Construction Documentation Report  
**Landfill Gas Collection and Control  
System Expansion 2011**  
Johnston County Landfill (Permit# 51-03)

Subject: Transmittal Letter for Construction Documentation Report Revision  
Landfill Gas Collection and Control System Expansion 2011  
Johnston County MSW and C&D Landfill Facility  
SW Permit #51-03  
Smithfield, North Carolina

Subject: Response to comments, Permit Modification  
Johnson County Landfill Gas Collection and Control System Project

DATE: 11/30/10  
SCALE: AS SHOWN  
DRAWING NO. 2

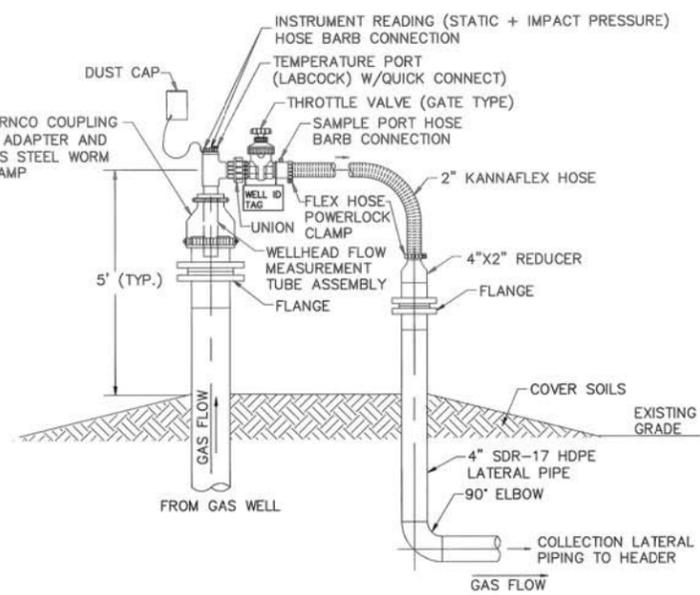
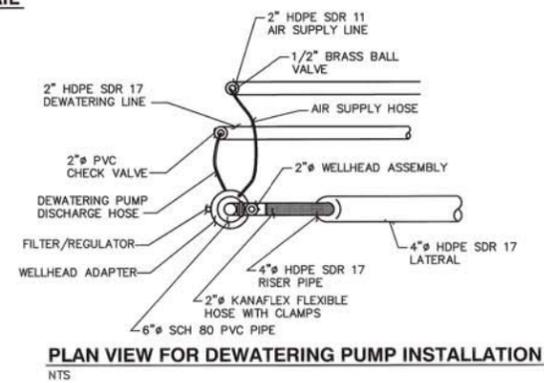
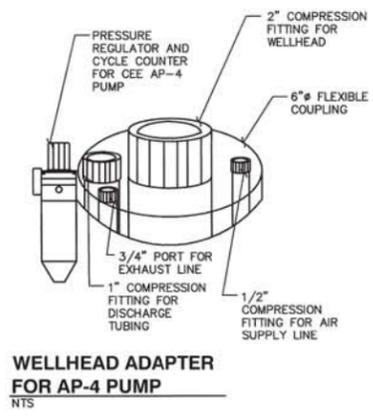
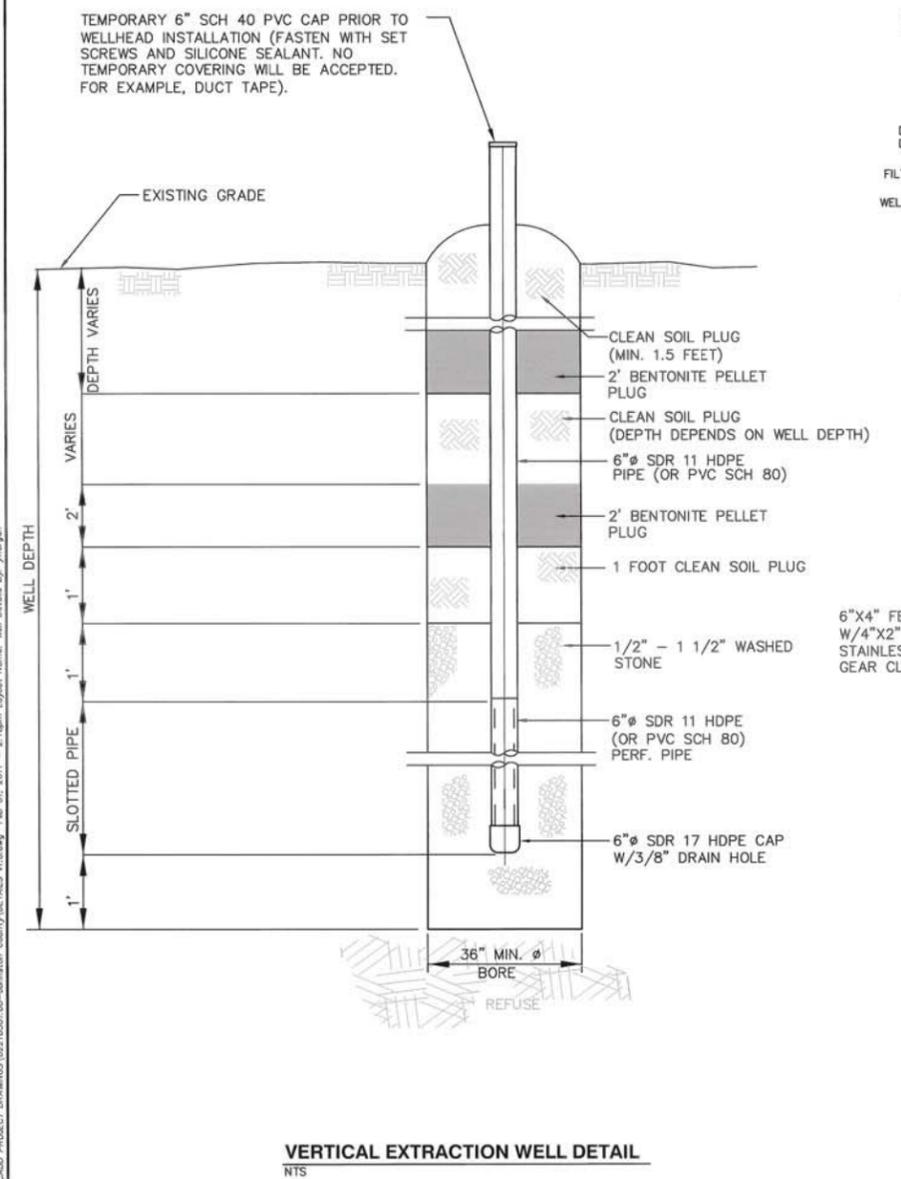
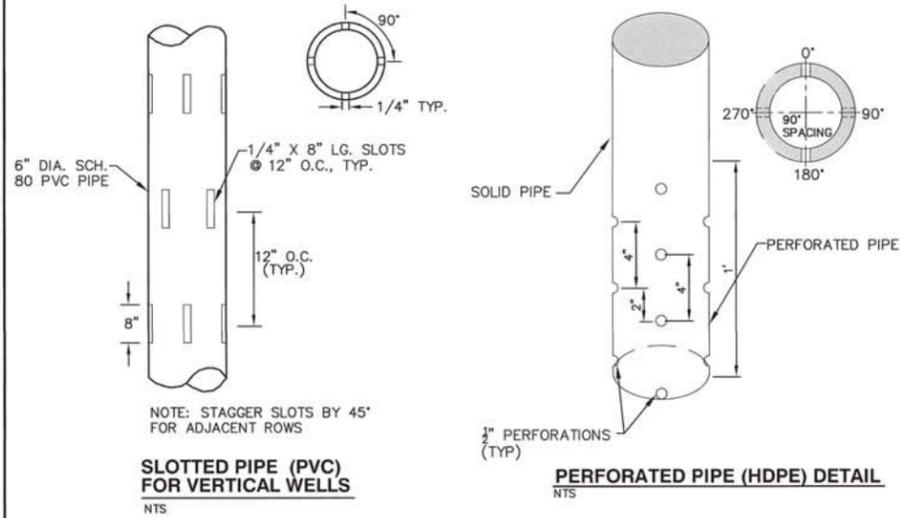
- ii. *Since gas extraction wells will be installed in the Phase 3 & 4 areas, the synthetic cover systems (FML and GCL) will likely be penetrated, if wells are not located on side slope areas. Therefore, please provide details of the connections (boots) and seals around the well casing and liners on Drawing 4 of 6.*
